APPLICATION FOR VARIANCE OR APPEAL

Jonathan Ochshorn

May 28, 2013

PETITION NO:  
**2013-0250**

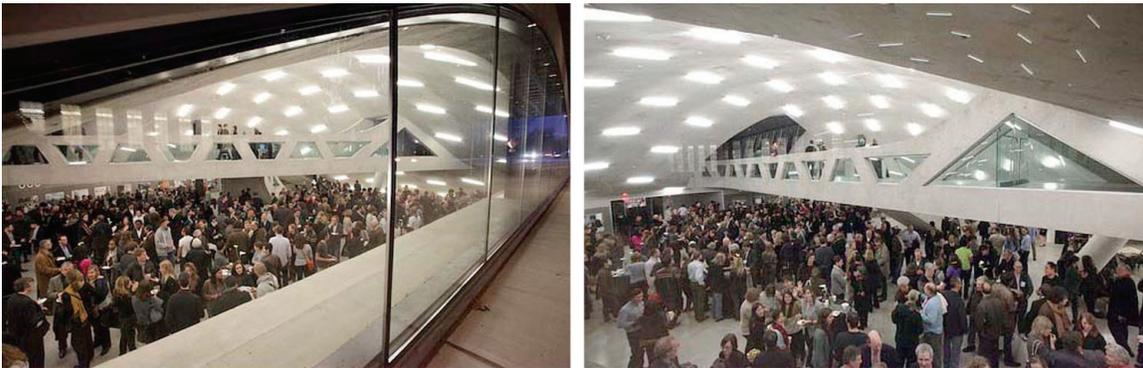
The “crit space” in Milstein Hall’s lowest level, directly under its concrete dome, is an assembly space with an area of approximately 3,600 square feet (this number is based on my calculations; the area is 4,978 square feet according to the Milstein Hall Dec. 5, 2008 “Issued for Construction” working drawings). Occupancy is “assembly without fixed seats” (2002 Building Code of NYS, Table 1003.2.2.2) with 7 square feet per occupant, corresponding to “Concentrated (chairs only – not fixed),” so the space should be designed for at least  $3,600 / 7 = 514$  people, and should therefore have three exits (Section 1004.2.1.1, 2002 Building Code of NYS). If the space is used as “Standing space” with 5 square feet per occupant (2002 Building Code of NYS, Table 1003.2.2.2), as it often is—see Figure 1—then the space should be designed for at least  $3,600 / 5 = 720$  occupants.

**Figure 2.** Egress from Milstein Hall crit space (a) as it actually is; and (b) with the room hypothetically extended into the corridor. Drawing by Jonathan Ochshorn based on Milstein Hall plans.

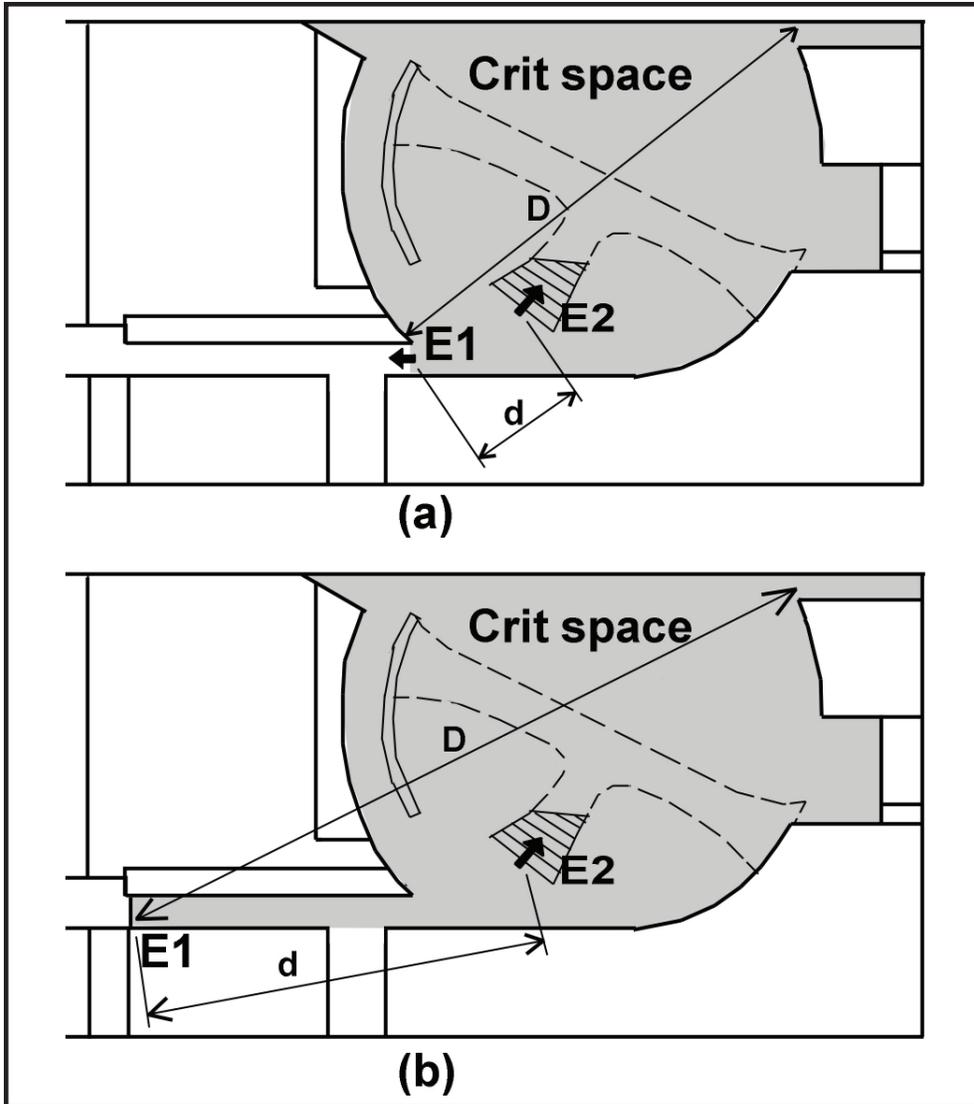
However, even assuming two exits are appropriate, these two exits must be “placed a distance apart equal to not less than one half [or one third for this sprinklered space, per exception 2] of the length of the maximum overall diagonal dimension of the building or area to be served” (2002 Building Code of NYS, Table 1004.2.2.1). The exits from this space do not comply with this separation requirement. Rather, the two exits—the first opens to a corridor and the second consists of a stair leading to an overhead bridge—are immediately adjacent to each other without adequate separation distance (Figure 2a).

I was first informed by Gary Wilhelm, Project Director at Cornell, that egress compliance is achieved by considering the corridor leading from the crit room space *to be actually part of the crit room space*, thereby extending the separation distance between the first exit (now “moved” to the far end of the corridor) and the second exit (the stair), as illustrated in Figure 2b.

This explanation violates both the letter and spirit of the exit requirements in the 2002 Building Code of NYS. While an expert Code opinion on this question is not binding on local Code Enforcement Officials, the following opinion, written by Michael W. Giachetti, P.E., Senior Staff Engineer for the International Code Council, does raise substantial doubts about the judgment of those charged with implementing the Milstein Hall project. He stated, in an email to me dated March 5, 2012:

**Figure 3.** Common path of travel from crit space exceeds 75-foot limit: partitions and furnishings preclude measuring this distance as a single straight line. Drawing by Jonathan Ochshorn based on Milstein Hall plans.

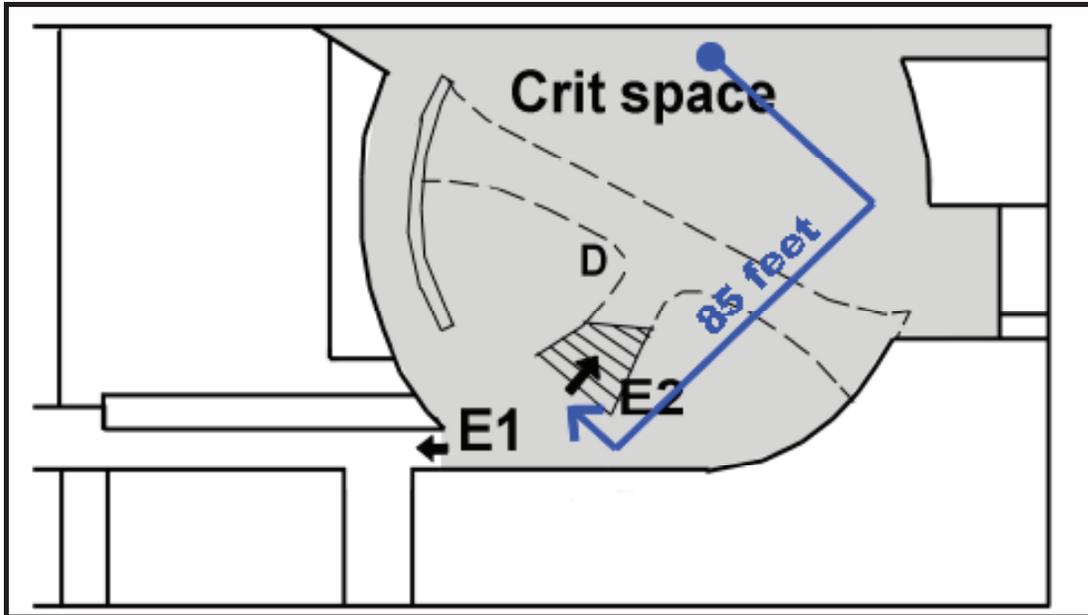
First, this is not what the Building Code requires: the common path of travel limits must be complied with, *and* the two required exits must be separated from each other by a minimum code-specified distance. Meeting one of these requirements does not allow you to violate the other. Second, it is not even true that the 75-foot limit for common path of travel (2002 Building Code of NYS, Section 1004.2.5) is met: see Figure 3. Common path of egress travel is rarely measured “as the crow flies”; rather, the measurement must account for typical placements of chairs, desks, or partitions, as shown in Figure 3. This requirement is discussed in the *Commentary* to the 2009 IBC: “The route must be assumed to be the natural path of travel without obstruction. This commonly results in a rectilinear path similar to what can be experienced in most occupancies, such as a schoolroom or an office with rows of desks [see Figure 1016.1(2)]. The ‘arc’ method, using an ‘as the crow flies’ linear measurement, must be used with caution, as it seldom represents typical floor design and layout and, in most cases, would not be deemed to be the natural, unobstructed path.” Figure 1016.1(2) from the *Commentary* is reproduced below as Figure 4. The permanent partitions in the crit room, not shown in Figure 3, but illustrated in Figure 5, make it absolutely critical that the common path of egress travel accurately reflects the “natural path of travel” around such partitions or chairs.

All three of these code-required provisions—an adequate number of exits, exits placed an adequate distance apart, and common path of egress travel requirements—are not met in this space, making it triply noncompliant and dangerous.

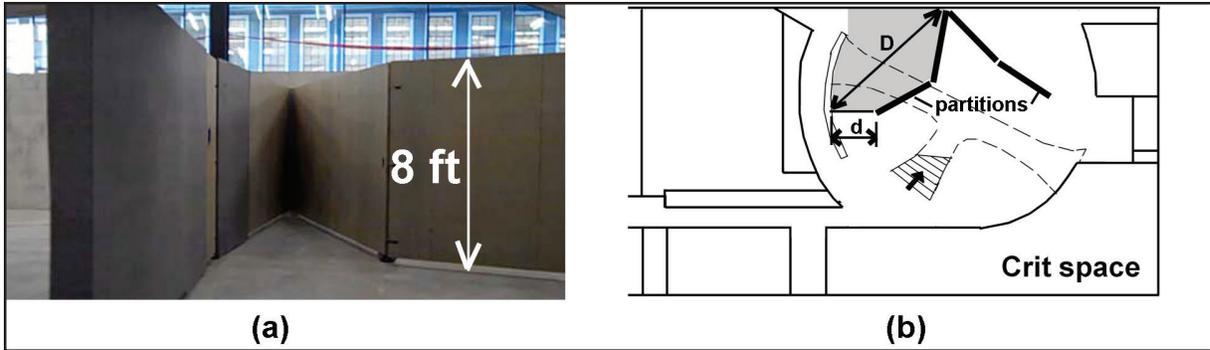
Moreover, the crit room space has been subdivided into several “flexible” spaces with permanent 8-foot high movable partitions. These partitions can be configured in ways that also create assembly rooms, each required to have two separated means of egress. Some configurations create conditions where only a single means of egress is provided even when the calculated occupancy exceeds 50 people (Figure 5).

These partitions are not lightweight dividers equivalent to pieces of furniture. Rather, they are quite substantial—in fact, far more substantial than typical room-dividing partitions—and consist of welded structural-steel frames clad with layers of plywood, Homasote, and felt. They extend a full eight feet above the floor and are permanently fastened to the building's structure. That they can also be moved into positions where they do not create noncompliant spaces is not relevant: the 2002 Building Code of NYS does not permit noncompliant spaces just because they are only noncompliant some of the time. A building must be Code-compliant in *all* of its possible configurations.

of 49; the 2002 Code has a limit of 50]. An alternative remedy would be to add additional, remote, exits from the space, corresponding to the calculated occupancy.

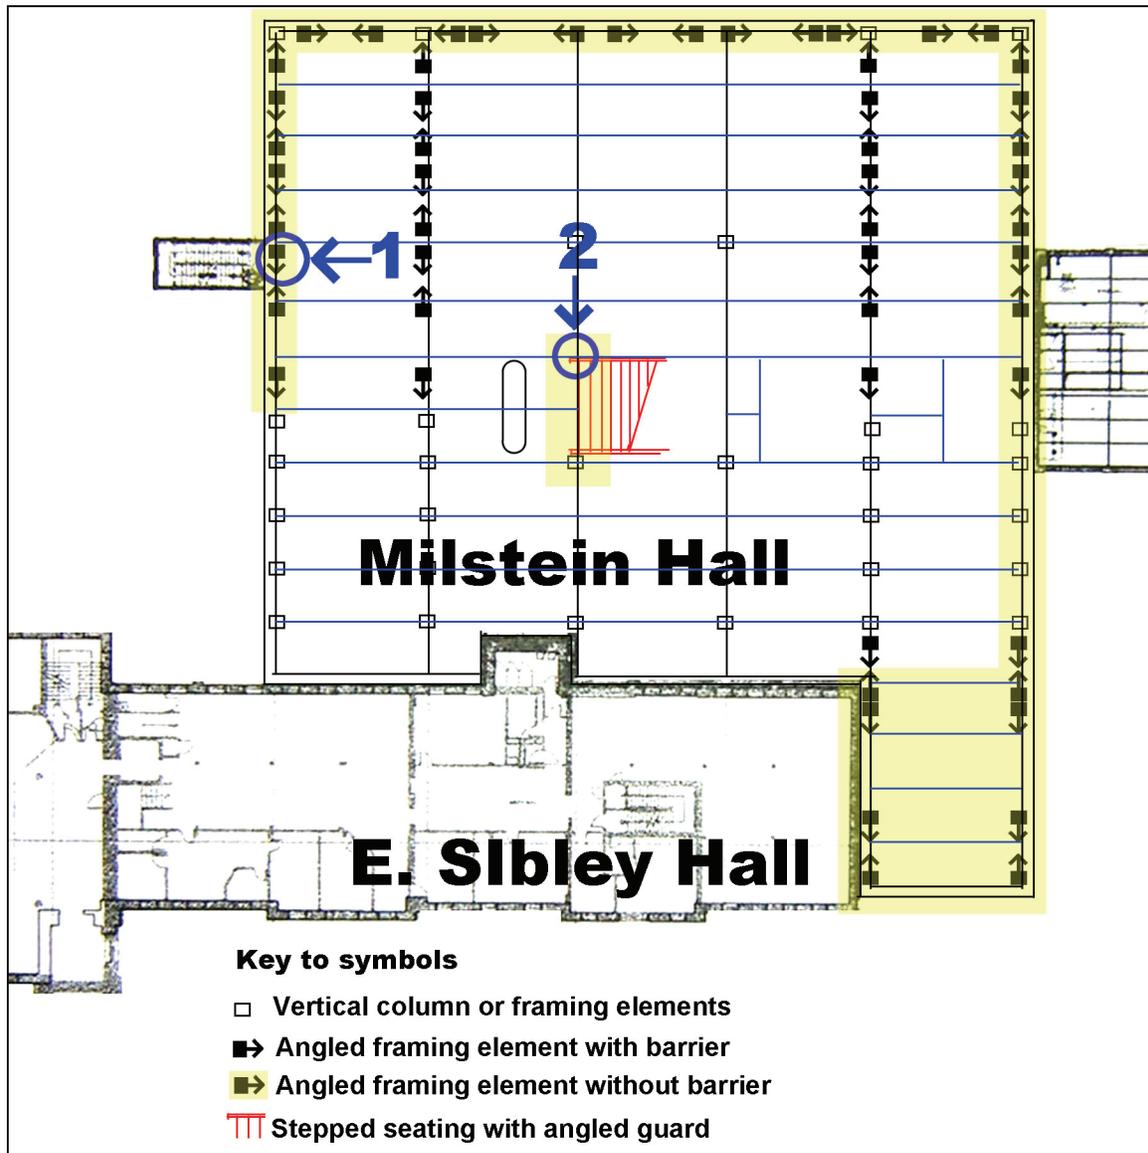
Sections 1003.2.5.1 and 1003.2.5.3 of the 2002 Building Code of NYS specify that protruding objects that reduce headroom below 80 inches or project more than 4 inches horizontally over any walking surface between the heights of 27 and 80 inches are not permitted within the means of egress. Numerous instances of such protruding objects can be found on the second floor (studio level) of Milstein Hall, as shown in Figure 6.

*in a building or structure to a public way"* (emphasis added) so all of the aisles and passageways on the second floor plate count as part of the means of egress. Two types of protruding objects are present, as identified in Figure 6, and illustrated in Figures 7 and 8 below: angled framing elements which reduce headroom below 80 inches, and angled stepped seating guards that protrude horizontally more than 4 inches into the egress space.

To remedy this situation, barriers should be placed at all noncompliant angled framing elements and guards.

**Figure 9.** Second-floor plan: The fire barrier wall width, between Milstein Hall and E. Sibley Hall, is shown in red; openings are shown in blue. The aggregate opening width exceeds 25% of the fire barrier width. Drawing by Jonathan Ochshorn based on Sibley and Milstein Hall plans.

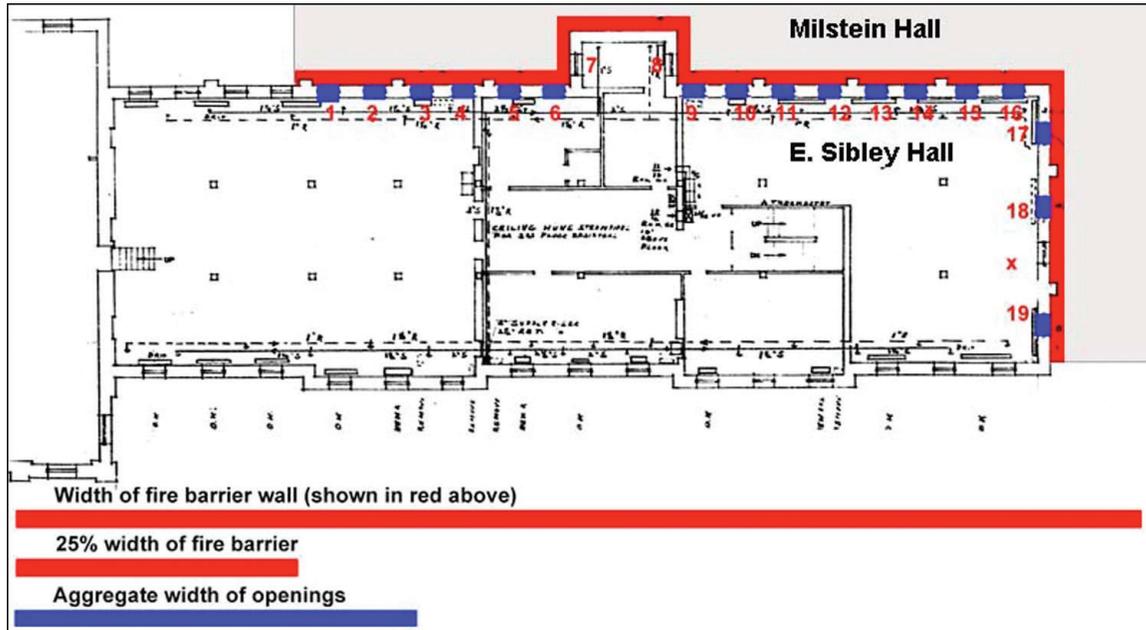
The fire barrier provided between Milstein and Sibley Halls is noncompliant. Section 706.6 of the 2002 Building Code of NYS limits openings in fire barriers to a maximum aggregate width of 25 percent of the length of the wall. The opening width in the fire barrier between Milstein and Sibley Halls exceeds 25 percent and is therefore noncompliant, as shown in Figure 9.

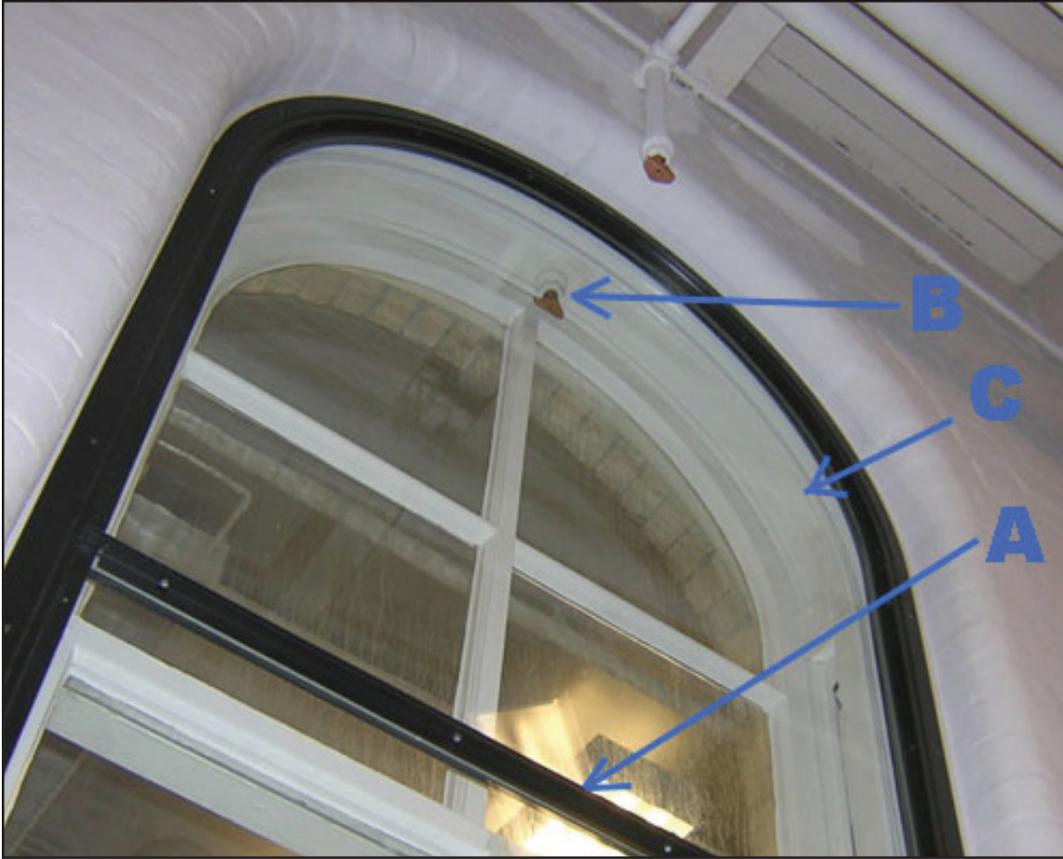
Gary Wilhelm, Project Director at Cornell, suggested to me that Tyco 5.6 K-Factor Model WS Specific Application Window Sprinklers could be provided to create a compliant fire barrier (Section 706.6, exception 3, 2002 Building Code of NYS). These sprinklers were, in fact, later installed. However, the Tyco product specifications indicate that this system is inappropriate for this application—i.e., not tested in accordance with ASTM E 119—for the following three reasons, illustrated in Figure 10:

- a) Such window sprinklers are *not* listed to protect windows when intermediate horizontal mullions are present (the Tyco prohibition against horizontal mullions is reproduced in Figure 11). In this Sibley-Milstein Hall application, horizontal mullions *are* present in the fire-rated glazing.
- b) The sprinklers cannot be sandwiched between new fire-rated glazing and existing windows, as they are in this application.
- c) All combustible materials must be kept two inches from the front face of the glass. In this application, wooden window frames are closer than two inches from the glass.

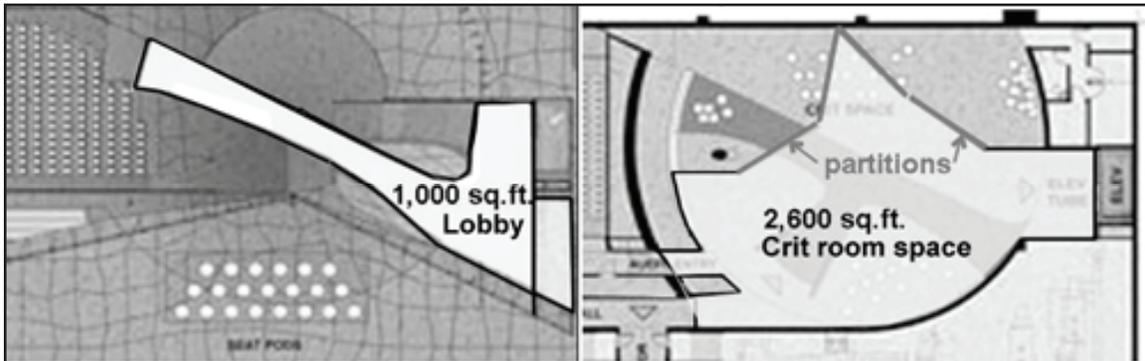
The movable partitions in the lower-level crit space of Milstein Hall create separate and smaller rooms within what was a single space, and therefore call into question the designation of the ground-floor lobby as a mezzanine (Figure 13). The lobby floor area is not less than one-third the area of smaller spaces that can be configured using the movable partitions (exactly what room the lobby is "in" when the movable partitions are deployed is difficult to determine), so the lobby appears to no longer satisfy the criteria for designation as a mezzanine.

If these partitions were permanently fastened to the floor within the domed space of the crit room, there is little question that they would be considered separate spaces or rooms. That they are permanent, but not fixed-in-place partitions (i.e., they are movable) should not alter this conclusion: they are constructed with heavy steel frames, studs, and plywood, and extend from the floor to a height of 8 feet; much like the construction of fixed-in-place partitions.

In either case—whether the lobby is judged to be *outside* the crit room space; or whether the size of the lobby is determined to exceed the size limit for mezzanines based on the floor area of the *partitioned* crit room—the lobby becomes a “story” rather than a mezzanine, and therefore at least two aspects of the building become noncompliant with the 2002 Building Code of NYS: a) unprotected floor openings now connect three, rather than two, stories in Milstein Hall in violation of Section 707; and b) required men’s and women’s rooms become two stories distant from the main studio floor level, in violation of Section 2902.4.1.

**Figure 14.** Approximate second-floor areas Halls (adapted from Cornell’s Milstein Hall web site by Jonathan Ochshorn)

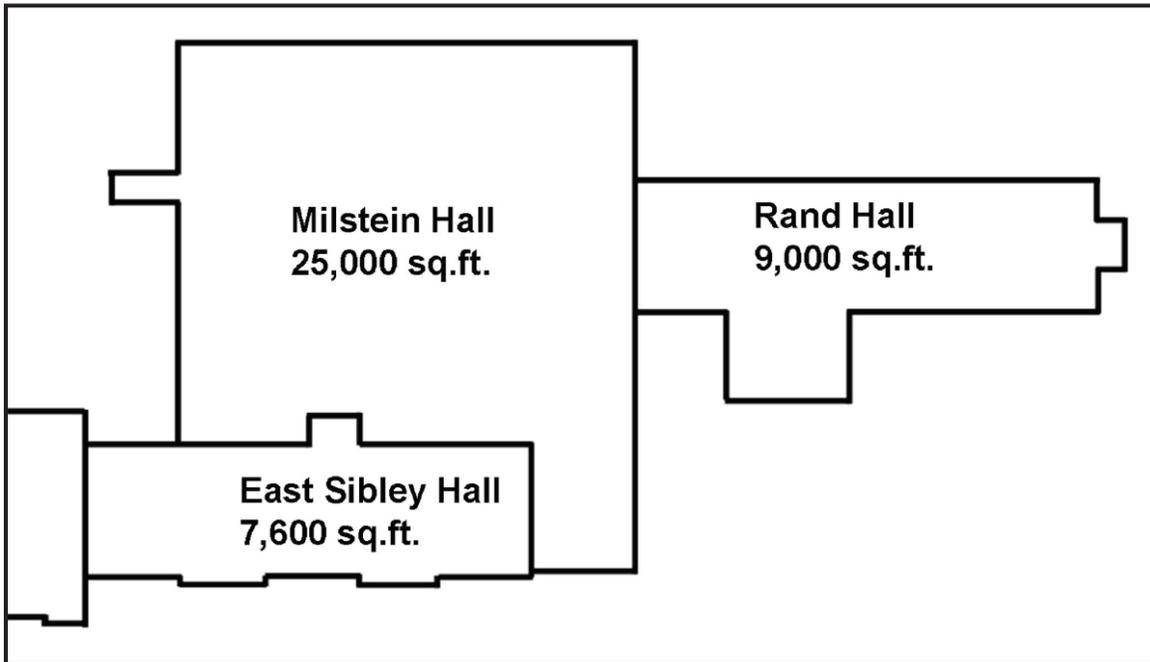
Milstein Hall is noncompliant under the 2002 Building Code of New York, since the total floor area of the combined buildings (Milstein-Sibley-Rand Halls) exceeds floor area limits based on Table 503 (Figure 14). Only by separating Milstein Hall from Sibley Hall with a *fire wall* or upgrading Sibley Hall to Type III-A construction would the floor areas be compliant.

The maximum allowable building area, per floor, tabulated in Table 503 of the 2002 Building Code of NYS is 6,000 square feet for an A-3 occupancy with V-B construction type (this construction type is determined by the construction of Sibley Hall). Adding 12,000 square feet for sprinklers and 4,500 square feet for frontage (the *maximum possible* allowance), we get a maximum allowable per floor area of 22,500 square feet—far less than the actual combined second-floor area. Assuming a Group B occupancy with a tabular maximum per floor area of 9,000 square feet, the total allowable per-floor area becomes 33,750 square feet, still far less than the actual combined second-floor area of this project.

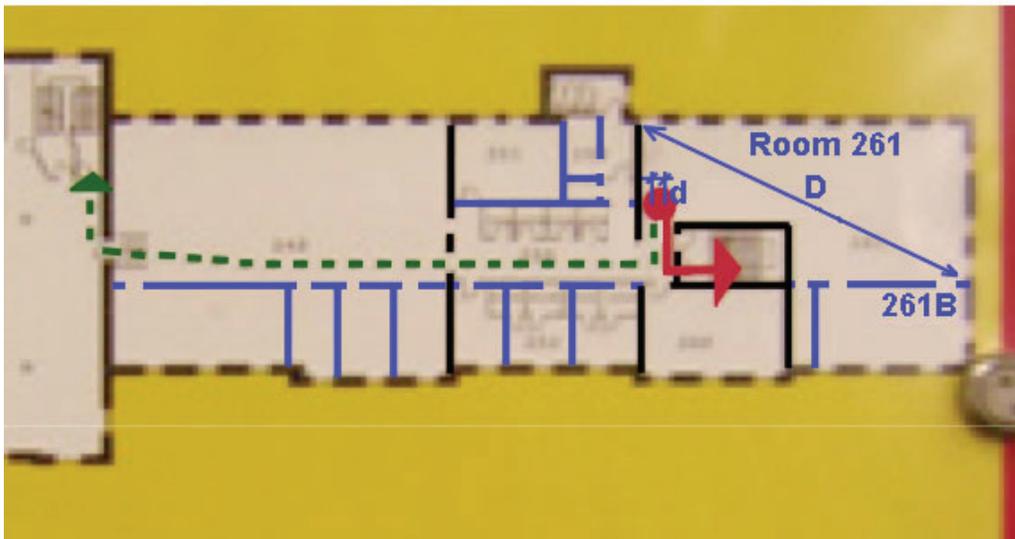
Milstein Hall does not meet current Code standards. By claiming that the current occupancy is within group A-3, the building architects and City of Ithaca Code Enforcement Officials appear to be violating those sections of the Code which (a) require them to designate each space according to its actual use; and (b) designate each use according to the occupancy it most closely resembles. The reason for designating the second-floor Milstein Hall spaces as both group A-3 and group B is clear: by doing so (in apparent violation of the Code), the building owner and architects are hoping that any hypothetical future alteration involving an A-3 lecture hall or library will be considered as a change to an equal or lesser hazard category (which it really isn't) rather than a change to a higher hazard category (which it really is).

The remedy for this is to enforce Section 302.3.3 (Separated uses) of the 2002 Building Code of NYS and to require that each portion of the building is individually classified according to its use.
